Docket Item #14
BAR CASE# 2005-0082

BAR Meeting
May 18, 2005

ISSUE: New garage/workshop

LOCATION: 607 N Columbus Street

Figure 2 Proposed alley elevation

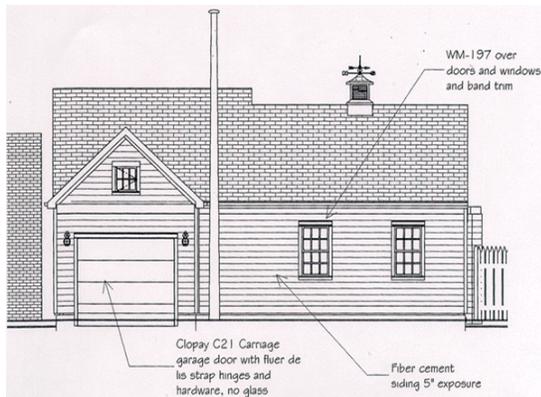
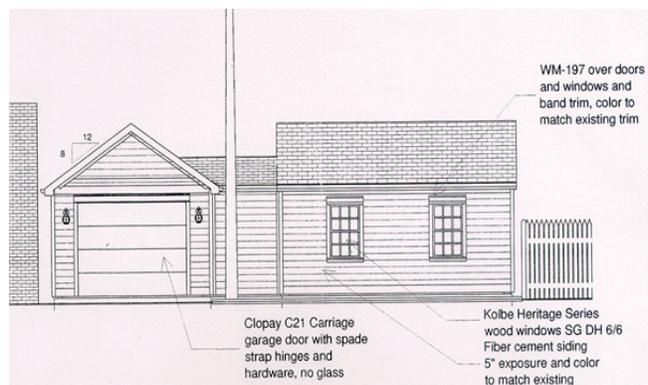
REASON: The Board believed that the proposed outbuilding was too tall and suggested that the pitch of the roof be made more shallow; that the building was too large and should be reduced in scale and that additional time was needed to address the comments of the Department of Transportation and Environmental Services.

In response to the Board’s comments about the overall massing of the structure, the applicant has made a number of revisions to the plans. The applicant has reduced the overall height of the roof by 6’; the depth of the garage section has been reduced by two feet; the width of the workshop has been reduced by 1’; and the width of the garage facing the yard has been reduced by 5’. Although the garage/workshop still maintains a large footprint, Staff believes that the reduction in height of the roof considerably reduces the overall mass of the building.

Update: In response to the Board's comments at the May 4, 2005 public hearing, the applicant has revised the design of the garage/workshop to reduce the height of the roof. In addition the overall size of the building has been reduced and now includes a small connector between the garage and workshop to break up the massing.

Figure 4 Proposed west elevation

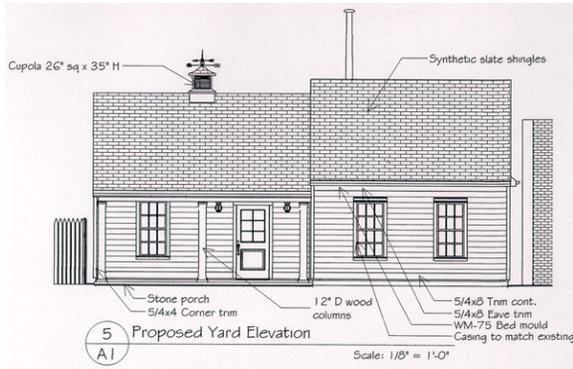
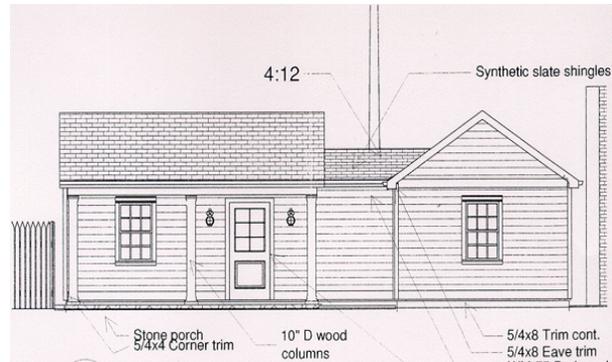
The west elevation of the garage includes two six-over-six windows and a wood door with six lights. A porch 5' in width and 19' in length will be located on the northern end of this elevation. The porch is supported by three 10" in diameter wood columns. The north elevation of the structure does not include any variation.
